**MONITORING YEAR 1
ANNUAL REPORT**
Final

CROSS CREEK RANCH SITE

Subject: Cross Creek Ranch Site – Monitoring Year 1 Draft Report
Montgomery County, NC
Yadkin River Basin – CU# 03040104
DMS Project ID No. 100138
Contract # 7879-01

Review Comments:

Figure 1b. Current Condition Plan View
 Cross Creek Ranch Site
 DMS Project No. 100138
 Monitoring Year 1 - 2022

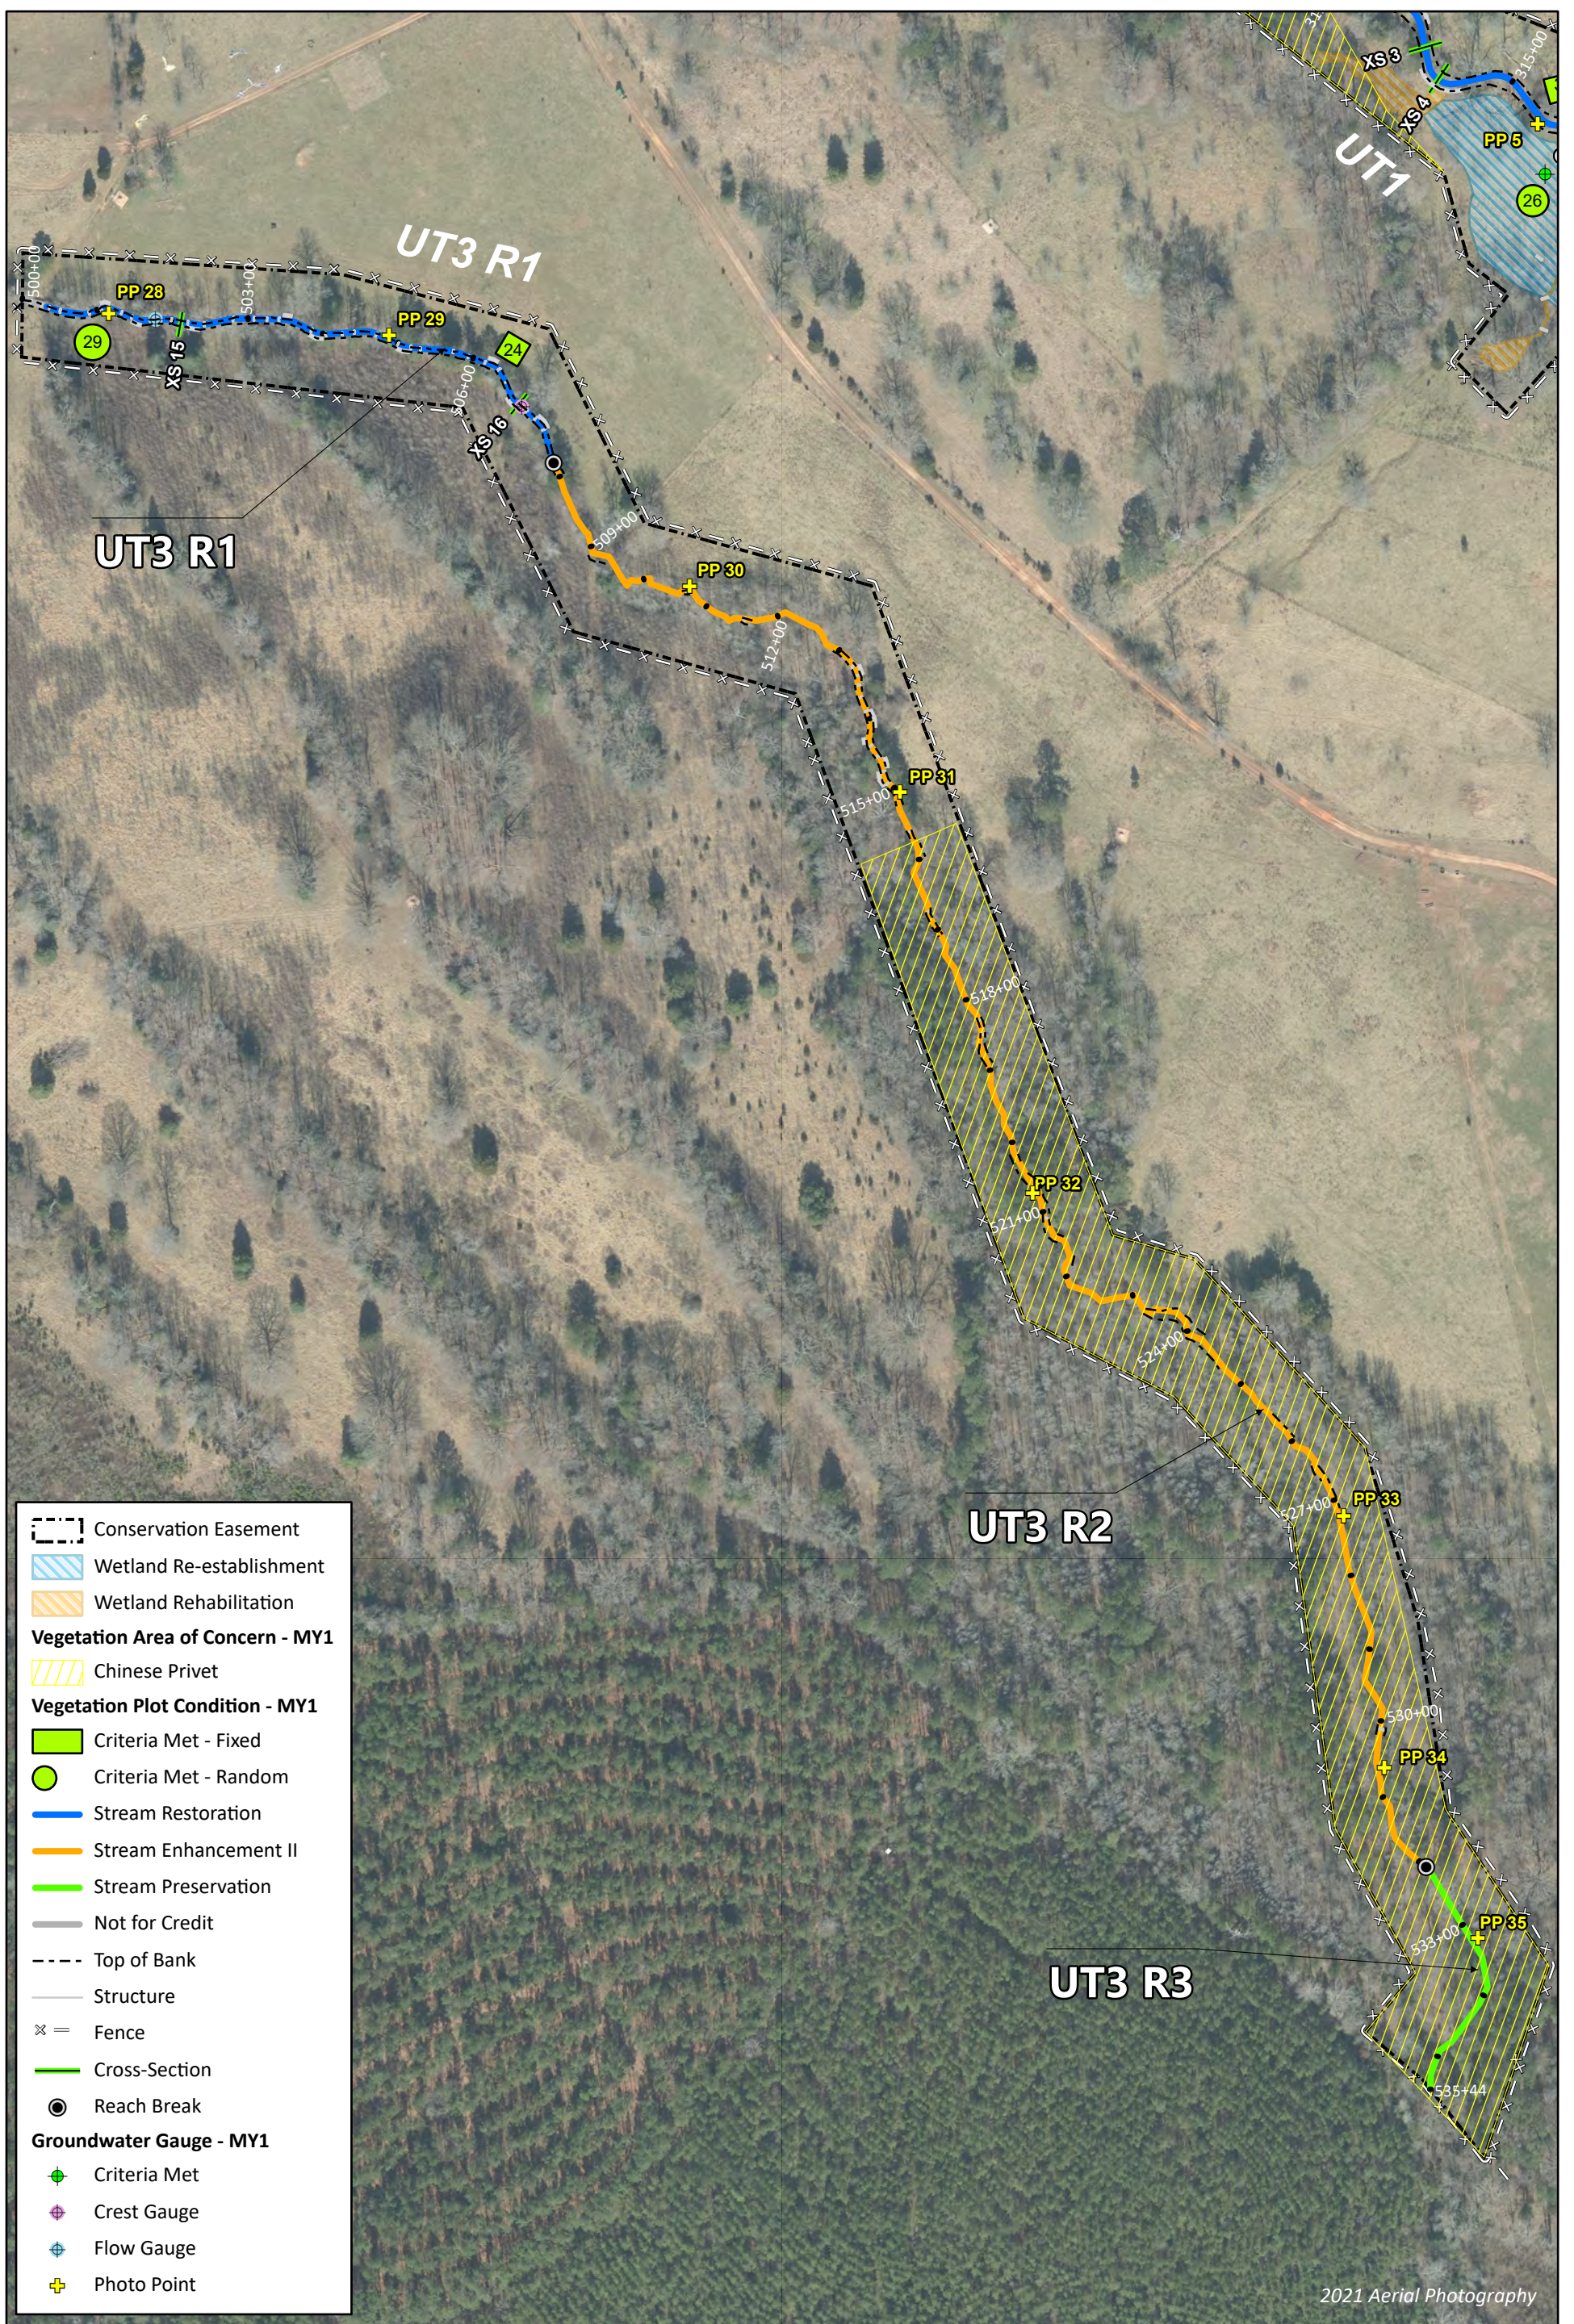
- [Section 1.2 – Monitoring Year 2 Data Assessment: The Table 2 goal of protecting the site from harmful uses includes visual inspection of the perimeter as the measurement criteria. Please summarize the monitoring activities and results associated with this goal and indicate if the entire easement boundary was observed during MY1 and marked in accordance with the marking specifications.](#)

Response: While the majority of the easement boundary was observed during MY1, it was not seen in its entirety. Easement marking specifications remain consistent with those portrayed in Figures 1a-c within boundaries observed during MY1. The boundary will be walked in its entirety during MY2, and the MY1 Monitoring Report has been updated to reflect this statement.
